# Memorandum

To	Peter Olak, P.Eng.	Page 1
CC	Dean Simpson, P.E., Zaineb Al Mumayez, P.Eng.	
Subject	<b>Geotechnical Review- Hamilton Rapid Transit Preliminary Design and Feasibility Study (B-line), September 2011</b>	
From	Gwangha Roh, P.Eng., Ph.D., Eric Tiedje, EIT, Ph.D., Miln Harvey, P.Eng., Ph.D.	
Date	October 14, 2016	Project Number 60507521

This memorandum presents a review summary of geotechnical evaluation and provides additional preliminary recommendations to finalize the B-line geotechnical EA report.

PRELIMINARY DESIGN  
KING STREET EAST GRADE SEPARATION  
RETAINING WALL 1/3  
PLAN AND ELEVATION

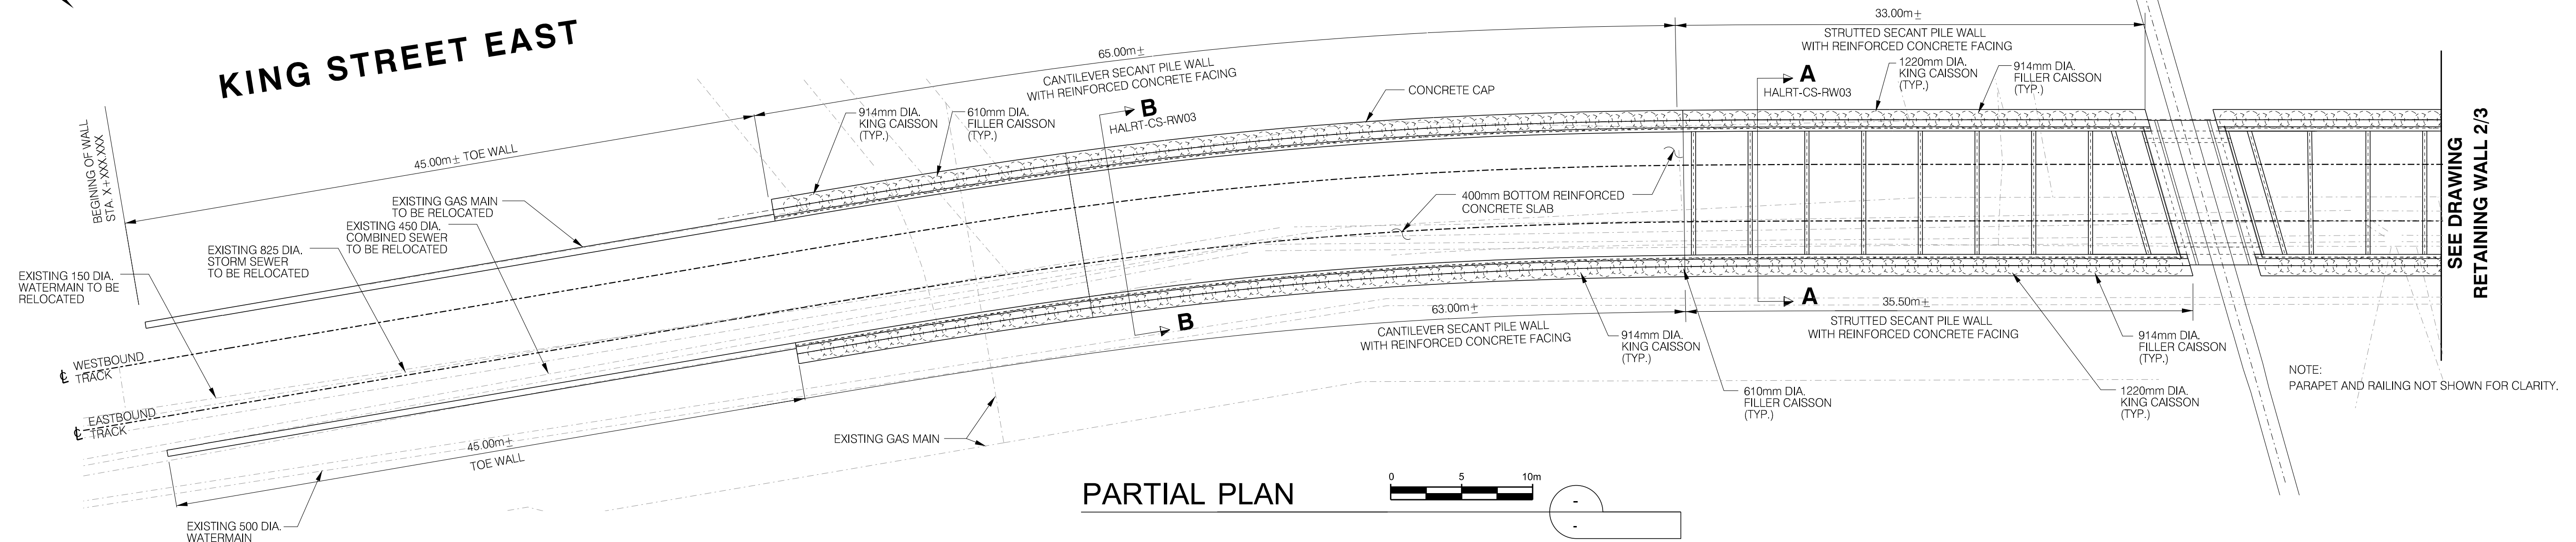
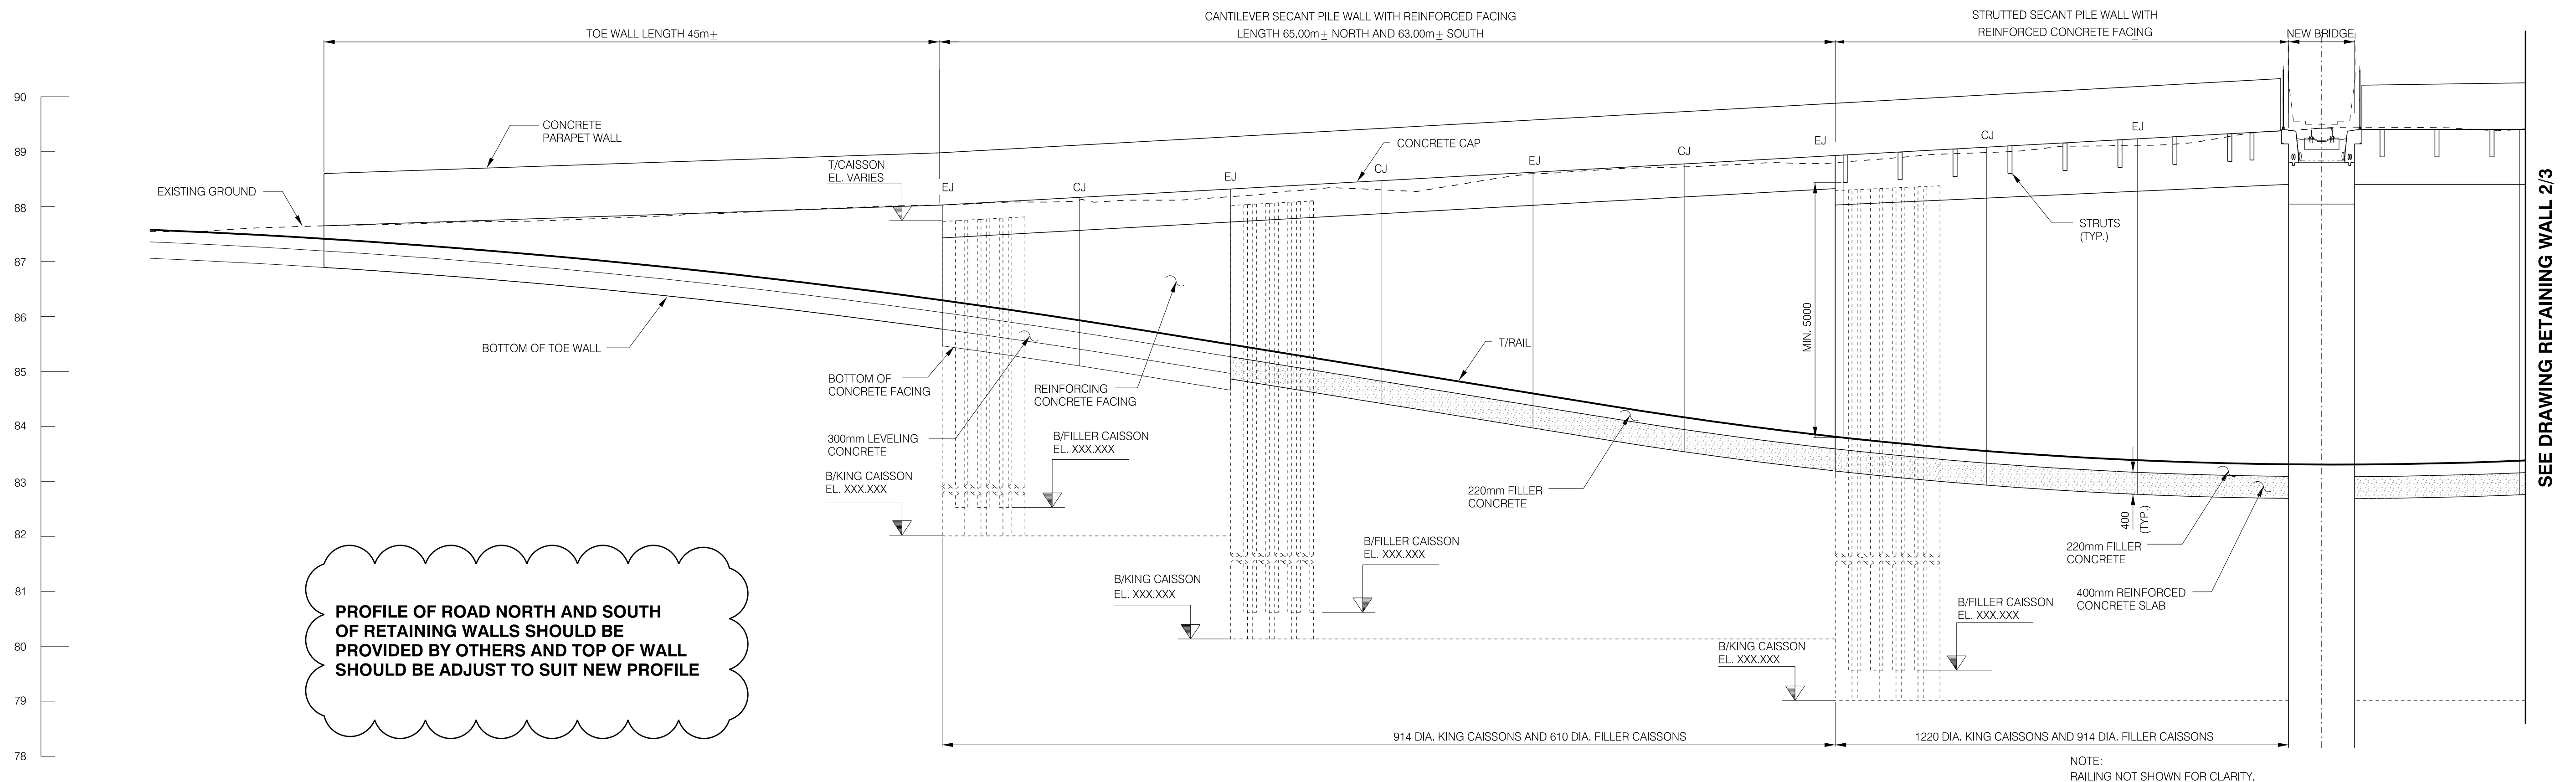
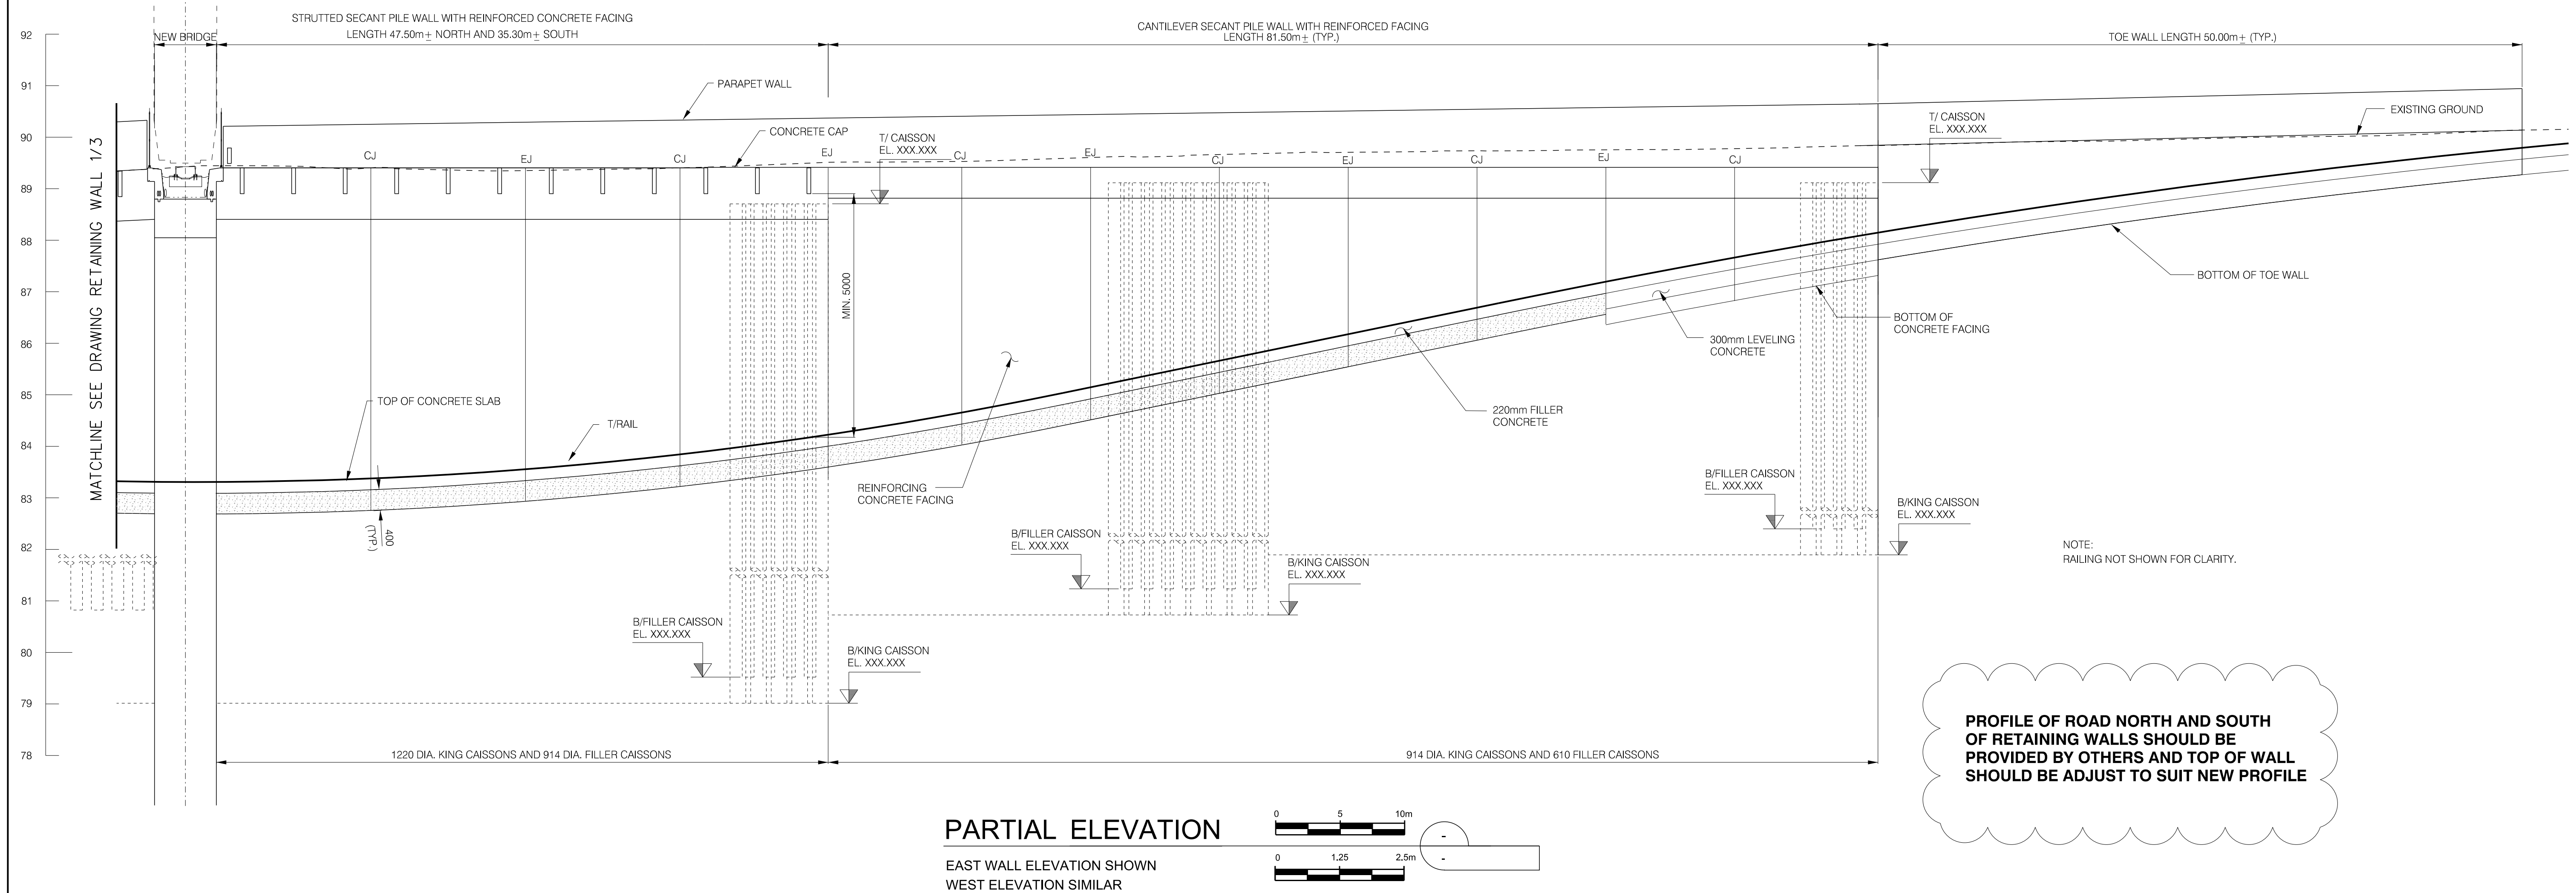
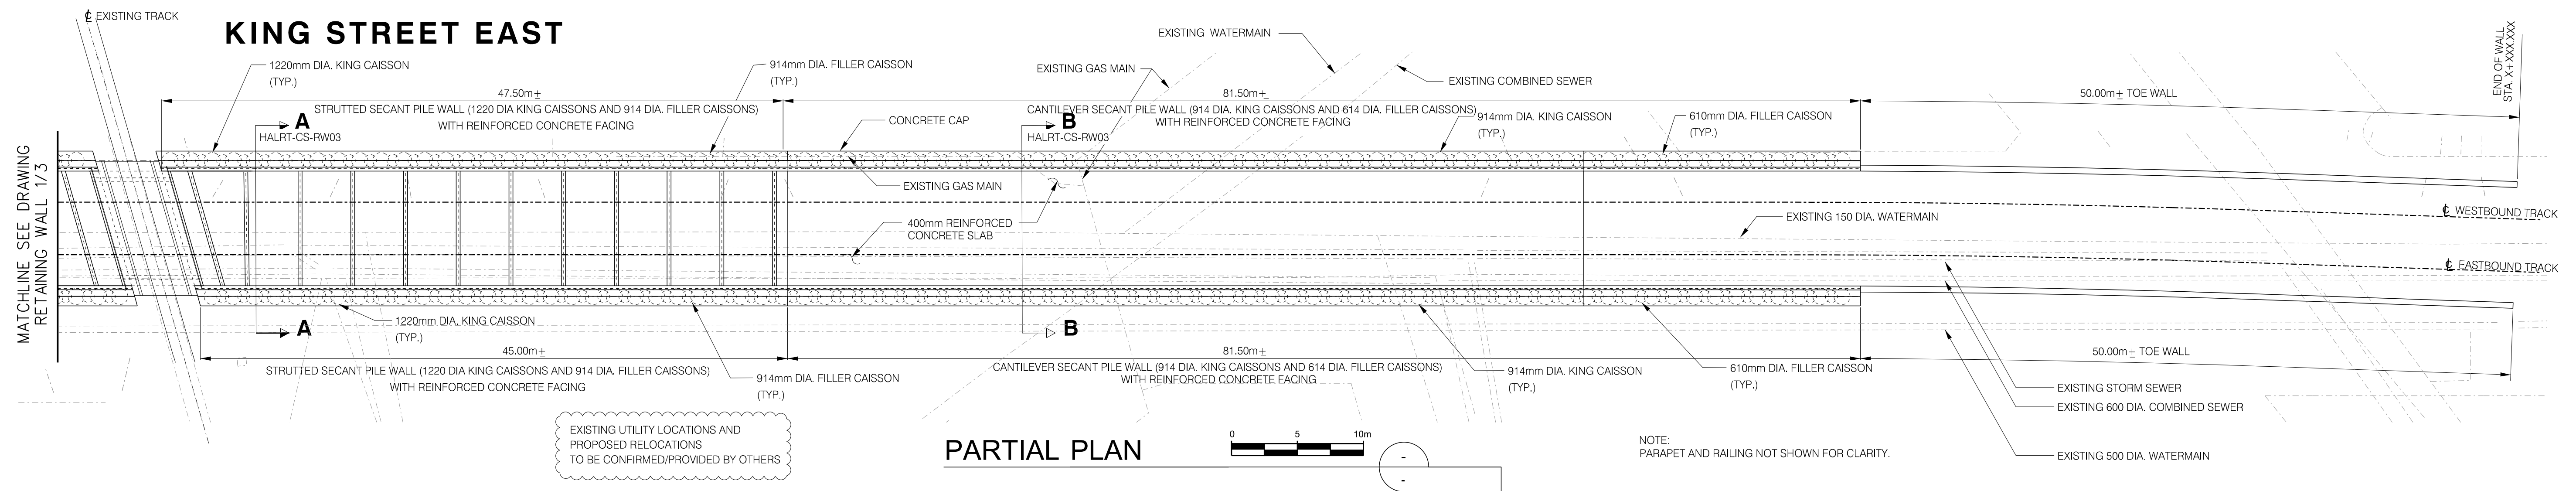
Based on the AECOM prepared GA drawing for this grade separation (included in Appendix A), approximately 6.5 m of vertical clearance will be provided for the LRT, and retaining walls (most likely in-situ walls, such as contiguous caisson wall or soldier pile and concrete lagging) will be constructed on both sides of the crossing.

For a temporary braced support of excavation (SOE) system, the earth pressure distribution (apparent) can be estimated as described in Section 26.10 of the CFEM (2006) or Chapter 28 of Metrolinx Design Criteria Manual (DCM). A typical triangular earth pressure distribution can be used for a temporary SOE without internal bracing, or permanent earth retention system design. Surcharge and water pressure should be taken into consideration, as appropriate, for all temporary excavation support systems and permanent earth retention systems.

A detailed construction staging plan and temporary excavation support design should be prepared in the detailed design phase.
